**RAI Volume 4, Chapter 2.4, First Set, Number 1:**

Response Tracking Number: 00564-00-00

RAI: 4.2.4-001

Figure 1 Planning and Document Hierarchy and Sequence of PC Test Implementation.

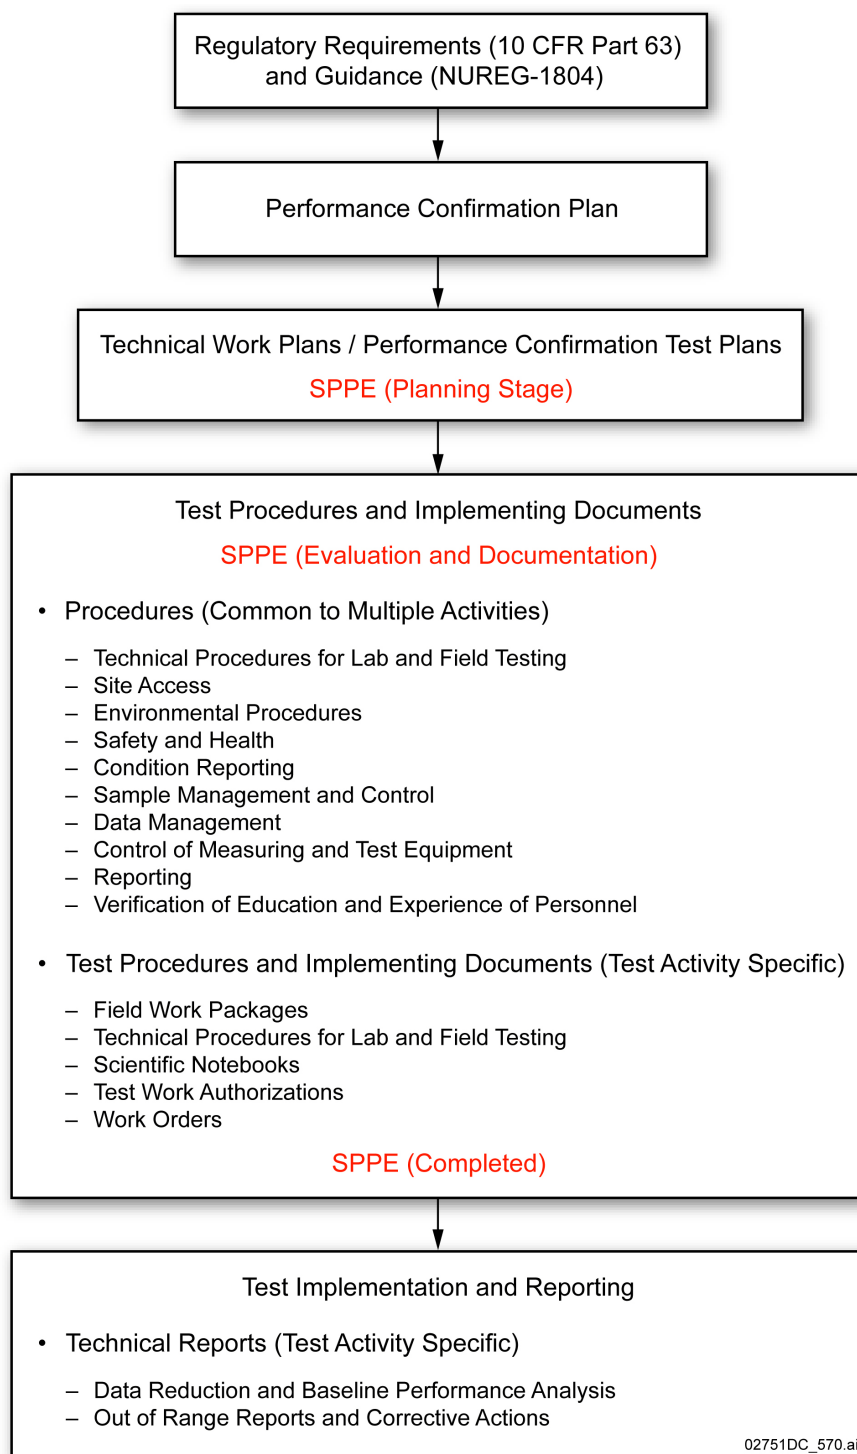
Clarify apparent inconsistencies as to where evaluations to determine waste isolation impacts due to test construction, performance confirmation activities, or both, will be documented.

Basis: In Section 5.1 of its Performance Confirmation (PC) Plan (SNL, 2008), the applicant stated that each performance confirmation activity is evaluated to assess relevance to waste isolation impact due to test construction, performance confirmation activities, or both. Also, in Section 5.2.2 of its PC Plan the applicant stated that PC Test Plans will require evaluations to ensure that planned testing does not adversely affect the ability of the geologic and engineered elements of the geologic repository to meet the performance objectives. Consistent with the applicant's stated requirement, the PC activity descriptions provided in the PC Plan include a brief statement about the potential for the activity to adversely affect the ability of the repository to meet performance objectives. For some PC activities, the lack of a potential for adverse effects is self-evident (e.g., off-site laboratory testing). Other PC activities are more complex. For example, the applicant stated in its PC Plan that future planning for waste package monitoring could require sensors placed directly on or through the waste packages. The applicant further stated an analysis or determination of impact will be conducted to evaluate if the instrumentation could affect the integrity of the package as compared to non-instrumented packages and that further evaluations on waste isolation and test-to-test interference will be conducted during the detailed test planning. However, it is not clear where such further evaluations will be documented.

In SAR Section 4.1.2, the applicant, citing the PC Plan, stated that during operations, the evaluation of effects on emplaced waste will be addressed in the PC test plans. However, statements in Section 5.2.3 of the PC Plan appear to indicate that evaluations of impact to emplaced waste, at least for some activities, would be conducted at a later stage of implementation and be documented in field work packages. Also, both the applicant's PC Plan and Section 4.1.2 of the applicant's SAR list the detailed information to be included in the PC test plans. An evaluation of the potential for the activity to adversely affect the ability of the repository to meet performance objectives is not among the twenty (20) items listed to be included in the PC test plans.

Evaluations for PC activities will be evaluated under the SPPE Program for impacts to waste isolation, test-to-test interferences, test construction, and adherence to relevant design control parameters. These evaluations will be documented in accordance with applicable procedures under the SPPE Program and are required by the PC test plan (SNL 2008, Section 5.2.2). SAR Figure 4-1 illustrates the planning and procedural document hierarchy for PC testing implementation. This hierarchy also reflects the approximate sequential ordering of activities for PC testing. Figure 1 (Planning and Document Hierarchy and Sequence of PC Test

Implementation) shows in red the SPPE sequence for planning, evaluation and documentation in approximate relationship with PC planning and implementation sequence and hierarchy. These evaluations are documented separately from PC test plans in accordance with applicable procedures under the SPPE Program.

In summary, test construction and performance confirmation activities will be evaluated for their impact to waste isolation prior to test implementation. These evaluations are documented separately from PC test plans and are part of the administrative controls that will be managed under the SPPE Program, in accordance with applicable procedures.

Figure 1. Schedule of Performance Confirmation

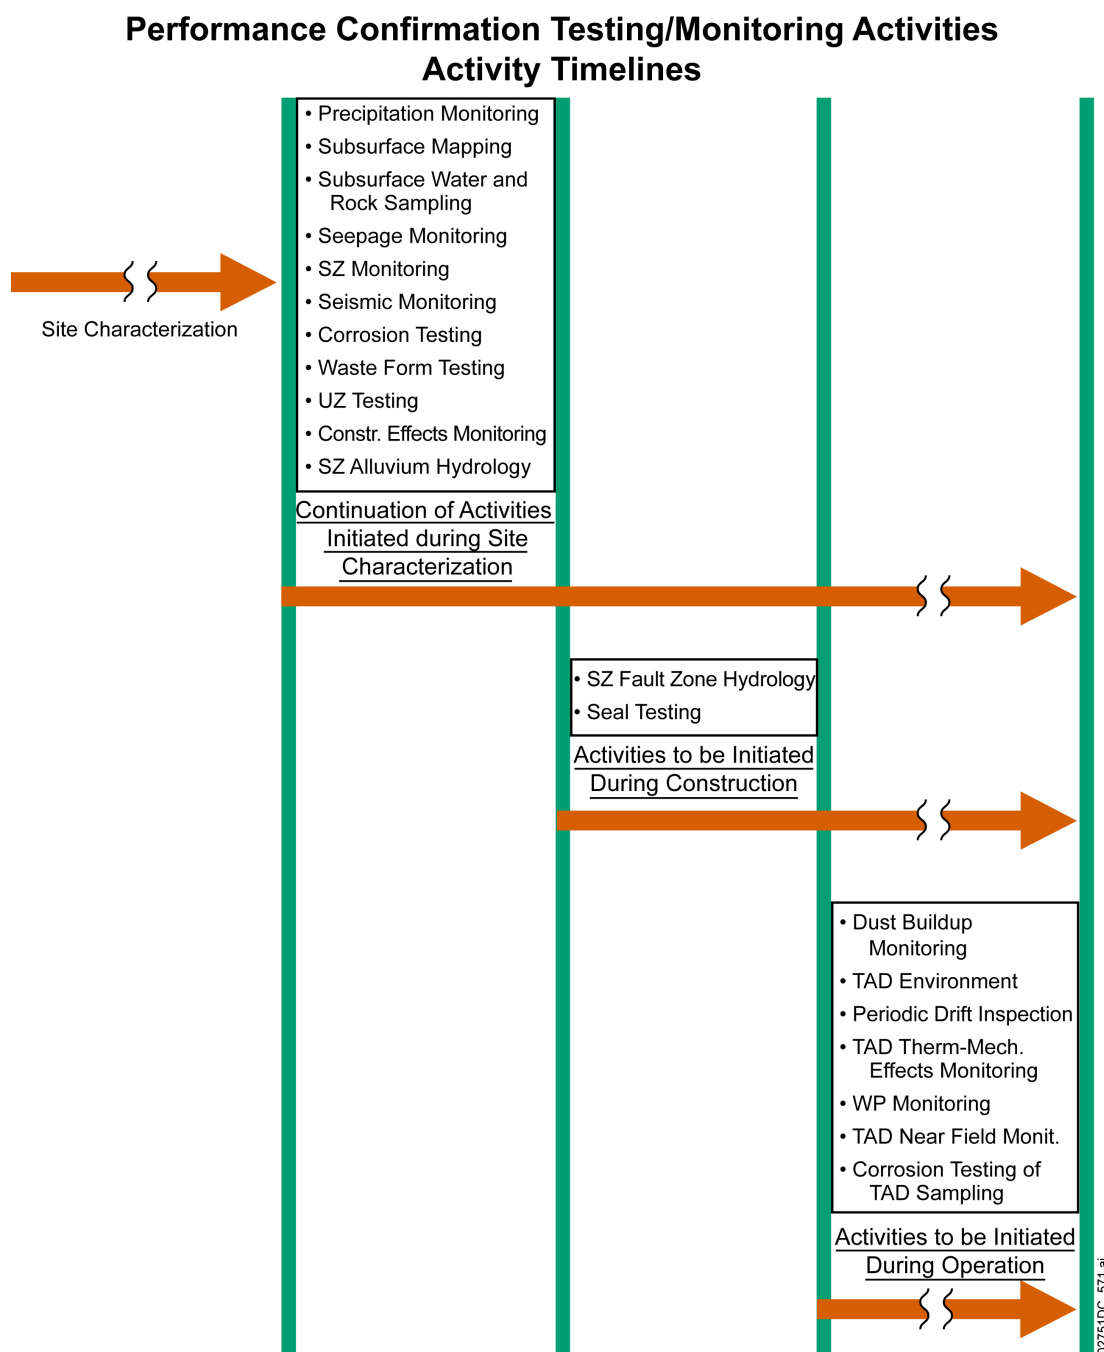
Provide a relative schedule for submitting each PC test plan to the NRC upon completion of the PC test plan so as to allow the NRC to review and evaluate any changes between the candidate and finalized parameters for that PC activity.

Basis: In its PC Plan, the applicant indicated that candidate parameters developed for its PC Plan remain preliminary until they are formalized in the more-detailed PC test plans. The applicant also noted that as PC test plans are developed, the rigor necessary for planning the details of the activity and developing expected limits and condition limits may result in the need to make some changes to the activity as described in the PC Plan, therefore, the anticipated methodology may deviate from the exact wording in the PC Plan. Justifications for deviations from the PC Plan will be documented in the PC test plans, when appropriate. The applicant stated this distinction between the PC Plan and PC test plans is necessary to ensure flexibility when testing and monitoring details are finalized in the PC test plans.

The milestones represented in SAR Figure 4-2 as vertical lines are project milestones: (1) the first vertical line is the end of site characterization, (2) the second vertical line is the beginning of construction, (3) the third vertical line is the beginning of waste emplacement, and (4) the fourth vertical line represents repository closure. The horizontal arrows shown in SAR Figure 4-2 represent the time frame during which the initial performance confirmation test plans will be completed. The underlined text in SAR Figure 4-2 explains whether the activity was conducted during site characterization or if it is a new activity that would be initiated during construction or during operations. The clarifying text for SAR Figure 4-2 is included as a note in Figure 1.

Table 1 shows the planned sequence of PC test plan development relative to repository construction and operation activities in greater detail than that shown in Figure 1. Figure 1 is focused on PC testing/monitoring activities, while Table 1 is focused on PC test plan development. In some cases the PC activity illustrated in Figure 1 represents a specific activity (e.g., periodic drift inspection) that is part of the broader PC test plan (e.g., drift inspection) shown in Table 1. As can be seen from Table 1, PC test plans that directly implement activities required during subsurface construction (e.g., subsurface mapping, seepage monitoring, subsurface water and rock testing, and drift inspection) are scheduled for completion before beginning subsurface construction. Additional PC test plans resulting from PC activities shown on SAR Figure 4-2 will be prepared during construction or during operations based upon technical need.
